Your Ref: SSD-10410

**Development Application SSD-10410: Maroota Friable Sandstone Extraction Project**

RE: DA SSD-10410 - Maroota Friable Sandstone  
Extraction Project – BDAR review on SAI

**Map 1** – Aerial of topography out to 2km from the subject land  
(Source: Nearmap 25/10/2021)

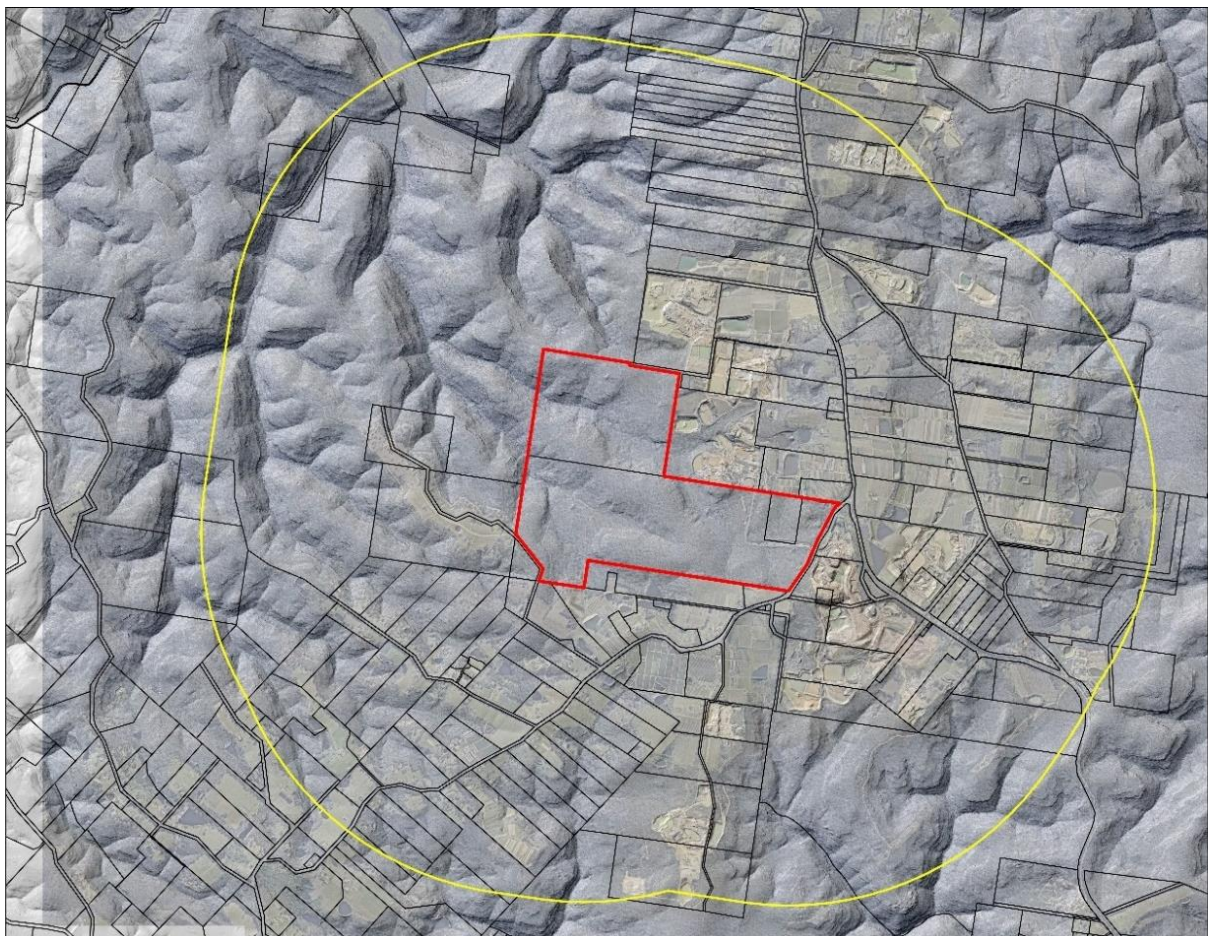
Maroota and the surrounding geology is well known to contain sandstone escarpments, many of which are likely to contain potential breeding habitat for the recorded Large-eared Pied Bat. Map 1 below shows the local topography on an aerial photo out to 2km from the subject land. Map 2 further below shows a zoom in of this landscape out to the immediately connective areas to the north and west on 30cm DEM Interpolation for hillshade. These clearly show the presence of rocky escarpments off the plateau edges where steeper adjacent slopes occur, and strongly dispute the assumption by Eco Logical that no nearby roosting potential exists.

- Large-eared Pied Bat – This species was recorded during surveys however the BDAR concludes that no suitable roost features were identified within the subject land and within the 2km buffer during aerial image and topographic analysis. A similar analysis by TreeHouse Ecology as shown in Maps 1 & 2 above clearly shows that there is potential for roosting and subsequent breeding habitat within 2km of the development footprint. Therefore, in the absence of an expert report or localised habitat searches beyond the site to prove otherwise, this species should be a candidate species for credit obligations.

- Eastern Cave Bat - This species was recorded to a possible level of certainty during surveys however the BDAR concludes that no suitable roost features were identified within the subject land and within the 2km buffer during aerial image and topographic analysis. A similar analysis by TreeHouse Ecology as shown in Maps 1 & 2 above clearly shows that there is potential for roosting and subsequent breeding habitat within 2km of the development footprint. Therefore, in the absence of an expert report or localised habitat searches beyond the site to prove otherwise, this species should be a candidate species for credit obligations.
